Dear Samuel,

Thank you for your comments and please see our reply below. Thanks.

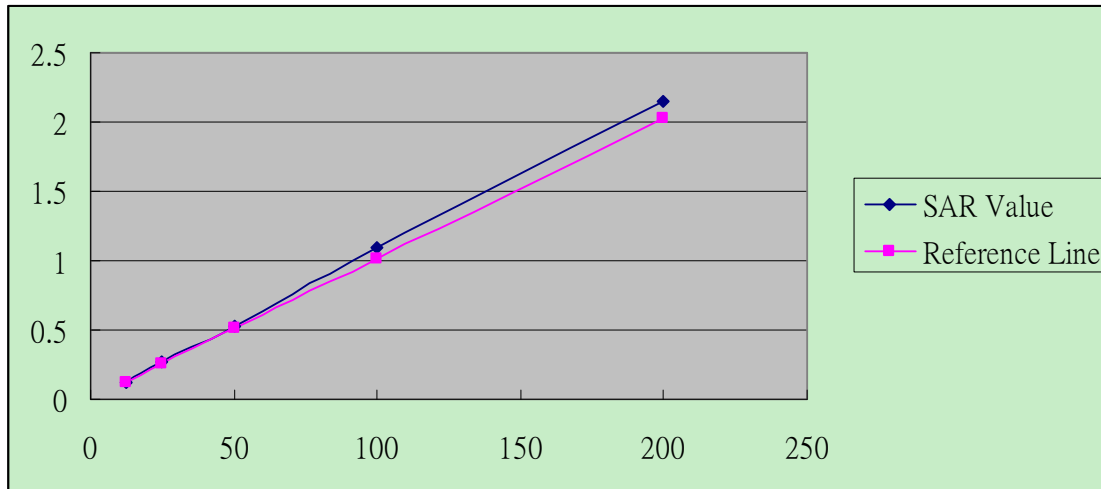
4. Please note that the reference lines in the SAR measurement linearity plots are incorrect. Reference line is established using measured points corresponding to probe sensors operating in the square law region; typically with the DUT operating at less than 20mW. The power at less than 20mW is used to establish the slope for the reference line for comparison with other measured SAR values to establish the error margin. Please show how your reference was determined and SAR estimated
<TCB reply> Please note that the SAR linearity plots is based on 12.5mW SAR test as we discussed in later Moto application. And calculated as below:
SAR at 12.5mw= 0.127

Expected SAR at 200mw= 0.127 x (200/12.5)= 2.032mw/kg
The measured SAR at 200mw= 2.15mw/kg
The error is (2.15mw/kg -2.032mw/kg)/2.032 mw/kg = 0.05807 = 5.81%
So the calculation in SAR report is correct. I copy related portion below for your convenient. Thanks.

From the above evaluation, it suggests that the SAR result is about 5.81% over estimated. Accordingly we believe that the final SAR result is conservative.
